HISTORIC AND DESIGN REVIEW COMMISSION

June 07, 2017

HDRC CASE NO: 2017-249
ADDRESS: 445 DEVINE ST
LEGAL DESCRIPTION: NCB 2957 BLK 1 LOT 12
ZONING: R-5 H
CITY COUNCIL DIST.: 1
DISTRICT: Lavaca Historic District
APPLICANT: Mauricio Namé
OWNER: Carlos Namé
TYPE OF WORK: Construction of a rear addition, exterior modifications, new 2-story rear accessory structure, hardscaping

2 NORTH EAST ELEVATION
3/8" = 1'-0"

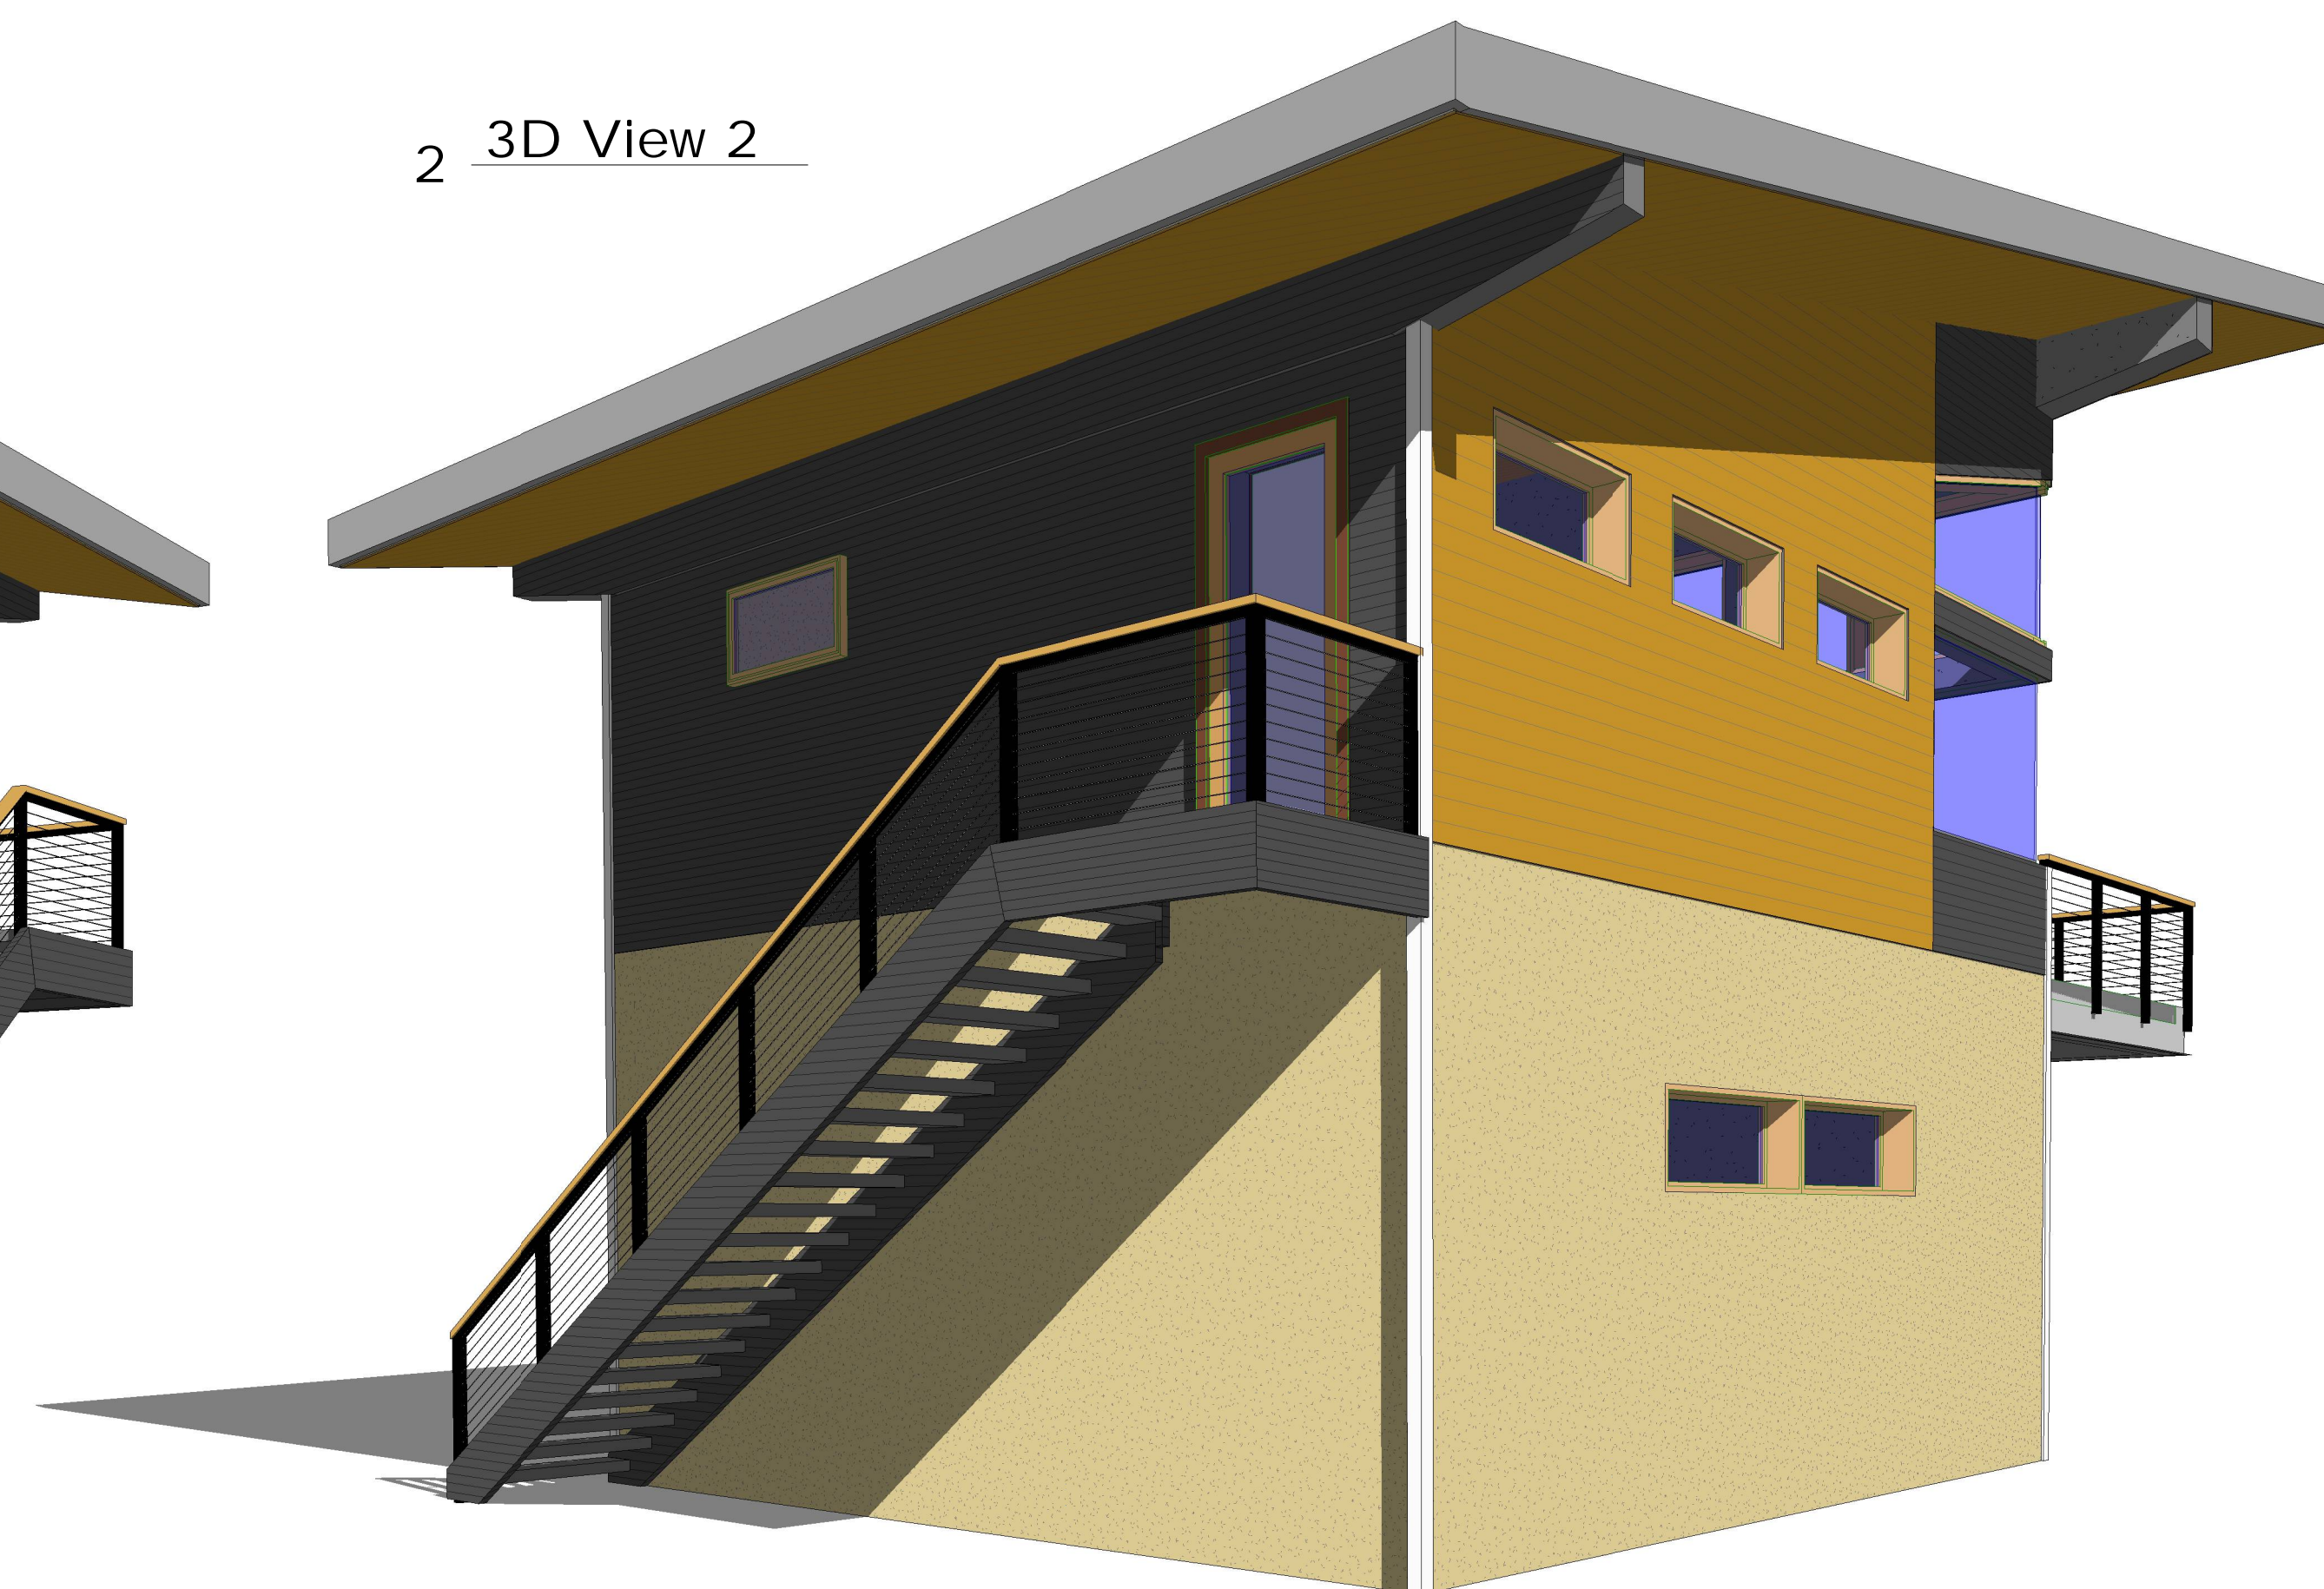
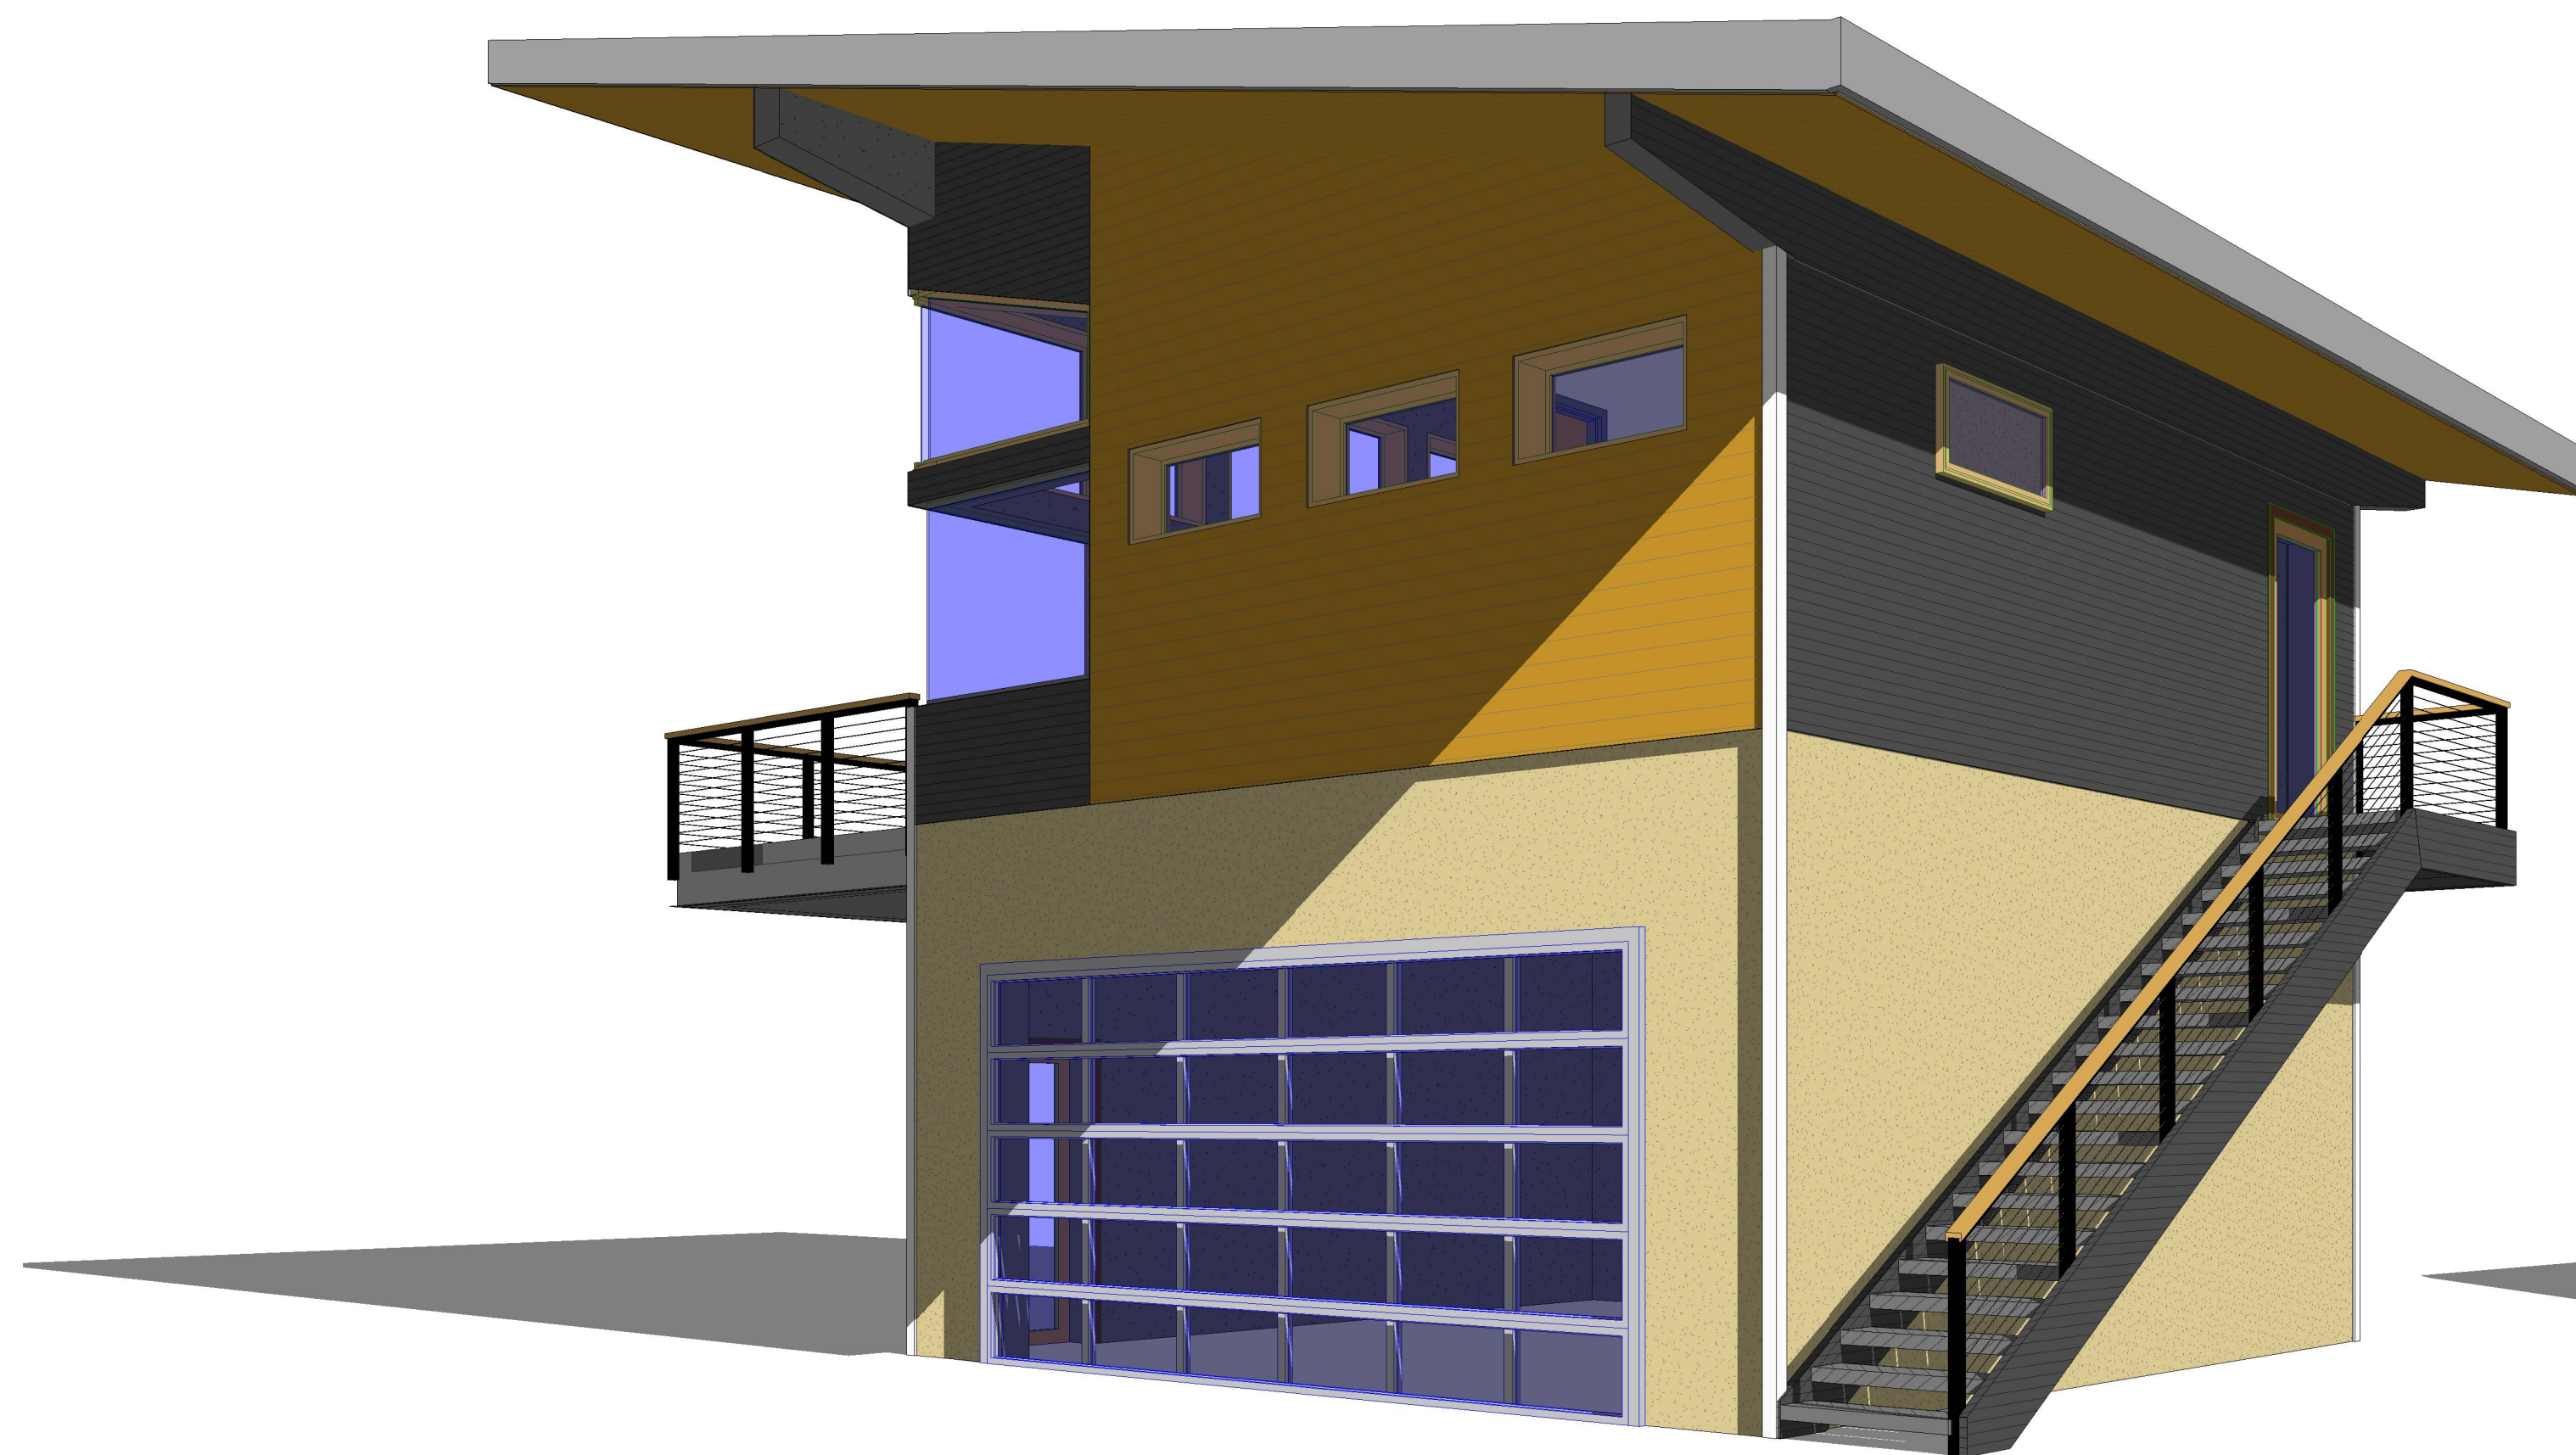
- q. **SCALE & MASS** – The applicant has proposed a two-story accessory structure with a sloped roof. According to the dimensions on the submitted elevations, the lowest point of the roof measures 21'-6" and the highest point measures 31'-3", both which are viewable from the public right-of-way. The first floor height measures 12'-0" and the second floor height measures 9'-6" up to approximately 18'-6" following the roof slope. The Historic Design Guidelines state that new construction should be consistent with the height and overall scale of nearby historic buildings. The ridge height of the primary gable of the existing historic home appears to measure approximately 20'-0" from the ground. In an elevation submitted by the applicant that indicates the height of the proposed accessory structure relative to the existing home, the new structure appears to eclipse the existing home's ridge height by over 10'-0" at its highest point. Additionally, the stairway on the side of the structure, which is viewable in full from the driveway, is almost the same height as the subordinate gable on the existing historic home. The height of the proposed structure would not only impact the view from the public right-of-way of the existing structure, but also affect the viewshed of the one and 1.5 story single family homes behind the lot

on Leigh St. Staff does not find the height of the proposed accessory structure consistent with the Guidelines or appropriate for the lot or the district.

- r. **ROOF FORM** – The applicant has proposed a two-story accessory structure with a sloped roof. The lowest point of the roof measures 21’-6” and the highest point measures 31’-3”. The roof is proposed to be standing seam metal. The guidelines stipulate that architectural details of new construction should keep with the predominant architectural style along the block face or within the district when one exists. Details should also be simple in design and should complement, but not visually compete with, the primary structure or adjacent structure. Staff finds the use of a sloping roof incompatible with the historic district, which is comprised of a high concentration of front and side gables or hipped roofs, especially within the immediate context of the lot. While similar roof styles can be found immediately adjacent to the Lavaca Historic District, there is no precedent for its use on a 2-story rear accessory structure within the district, especially in an area that is surrounded by one story single-family homes. Staff finds the proposal inconsistent with the Guidelines.

- s. **WINDOW & DOOR OPENINGS** – The applicant has proposed to install nine longitudinal rectangular fixed windows, five larger rectangular fixed windows with single muntins, and two large windows that follow the sloped roof pitch on the northeast and northwest elevations. According to the OHP Window Policy Document, windows used in new construction should maintain traditional dimensions and profiles found on the primary structure or within the historic district. Staff finds the windows inconsistent with the Guidelines.

- t. **MATERIALS: FAÇADE** – The applicant has proposed the use ICF concrete as the façade and structural material. The applicant has stated that the intention is to make the structure tornado-proof by utilizing this modern material. According to the Historic Design Guidelines for Additions, new construction should incorporate materials that complement the type, color, and texture of materials traditionally found in the district. Structures made exclusively of concrete are not characteristic of the district or surrounding context. Additionally, the elevations and renderings indicate multiple façade colors, but staff has not received material specifications that are tied to these delineations. Staff finds the proposal inconsistent with the Guidelines.

- Item 7, Staff recommends approval of the two porch railings and side staircase based on finding g and h.
- Item 8, Staff does not recommend approval of the 2-story rear accessory structure based on findings n through v. The application should address the following inconsistencies with the Guidelines if they wish to return with a new design proposal:

- i. That the applicant explores overall massing similar to historic structures and historic accessory structures in the vicinity as noted in finding p.

- ii. That the applicant reconfigures the roof form to be more consistent with the roof forms of the Lavaca Historic District as noted in finding q.
 - iii. That the applicant integrates window opening proportions that are more consistent with the Guidelines, the OHP Window Policy document, and the historic examples found in the Lavaca Historic District as noted in finding r.

- iv. That the applicant install windows that include traditional dimensions and profiles, be recessed within the window frame, feature traditional materials or appearance and feature traditional trim and sill details as noted in finding t.

- v. That the applicant incorporates architectural details and materials that are representative of the historic context of the district as noted in findings q through u.
